PC-7 MKII

Service Bulletin No: 53-012 Ref No: 74

FUSELAGE - GENERAL INSPECTION OF THE FORWARD ELECTRICAL BONDING POINTS

Bonding Strap - Removal/Installation Figure 1

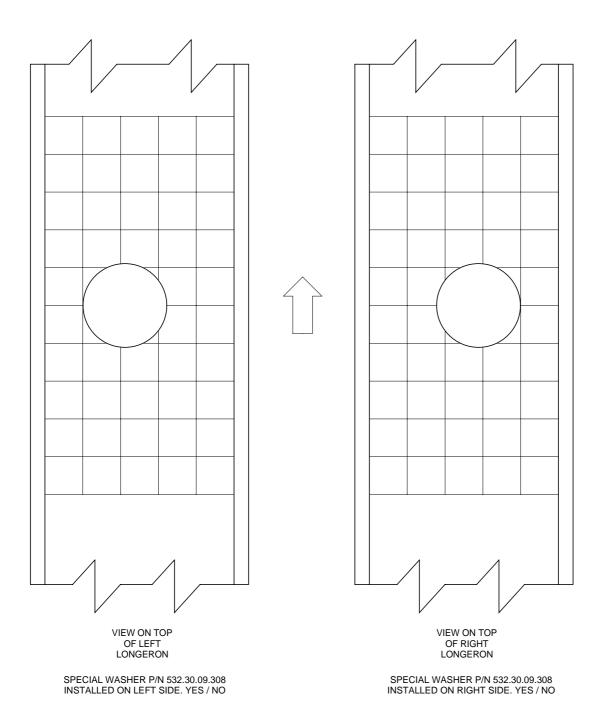
B. Remove the Bonding Strap (Ref. Fig. 1)

- (1) If the bonding connection is oversealed, use a non-metallic scraper and solvent (Material No. P01-008) to remove the sealant.
- (2) Remove the nut (7) and the washers (6).

(3) Remove the bolt (5) and washer (6) to disconnect the terminal lug of the bonding strap (4) from the longeron.

C. Inspection (Ref. Fig. 1)

- Examine the terminal lug for corrosion. (b)
 - (c) Remove all corrosion with Scotch-Brite (Material No. P02-016).
 - Examine the terminal lug again to make sure the protective tin coating is (d) serviceable. If you can see the copper metal of the terminal lug, remove the bonding strap (4) as follows:

- 3 Remove the nut (3) and washer (2).
- 4 Remove and discard the bonding strap (4).
- (3)Examine the attaching parts:
 - Use absorbent paper (Material No. P02-031) and solvent (Material No. P01-008) to (a) clean the removed bolt (5), washers (6) and nut (7).
 - (b) Examine the bolt, washers and nut for corrosion.
 - (c) Discard all parts that are corroded.

- Read and obey the manufacturer's instructions and apply Alodine 1132 (Material No. P07-021) to the bare metal area (Ref. AMM 20-40-10, Page Block 201).
- (b) If you did not enlarge the bolt hole or discard corroded parts:
 - 1 Connect the bonding strap (4) to the longeron with the bolt (5) the washers (6) and the nut (7).

- (c) If you enlarged the bolt hole or discarded corroded parts, use the new attaching parts from Kit No. 500.50.09.074.
 - 1 Put the special washer (P/N 532.30.09.308) on the new bolt (5) in place of the washer (6). Make sure the chamfered edge of the special washer faces up.
 - Install the bolt (5) with the special washer through the bonding strap (4) and the longeron.
 - 3 Install two new washers (6) and the new nut (7).
- (d) Measure the run-down torque of the nut (7).
- (e) Torque tighten the nut (7) to the measured run-down torque plus between 11 and 16 Nm (100 and 140 lb in.).
- (2) If you install a new bonding strap (4):

- 2 Install the bolt (5) with the special washer through the new bonding strap (4) (P/N 119.40.07.344) and the longeron.
- Install two new washers (6) and loosely install the new nut (7). 3
- (d) Put the bonding strap (4) on the bolt (1) at FR 1 and loosely install the washer (2) and the nut (3).
- In the engine compartment, hold the head of the bolt (1) and measure the run-down (e) torque of the nut (3).
- (f) Measure the run-down torque of the nut (7).
- Torque tighten the nuts (3) and (7) to the measured run-down torque plus between (g) 11 and 16 Nm (100 and 140 lb in.).
- (h) If necessary, at the right connection, replace the lockwire (Material No. P02-001) to the bolt (1) as recorded in the removal procedure.
- (3) Record if you installed or did not install the special washer(s) (P/N 532.30.09.308) on the copy of the Report Form (Fig 2).
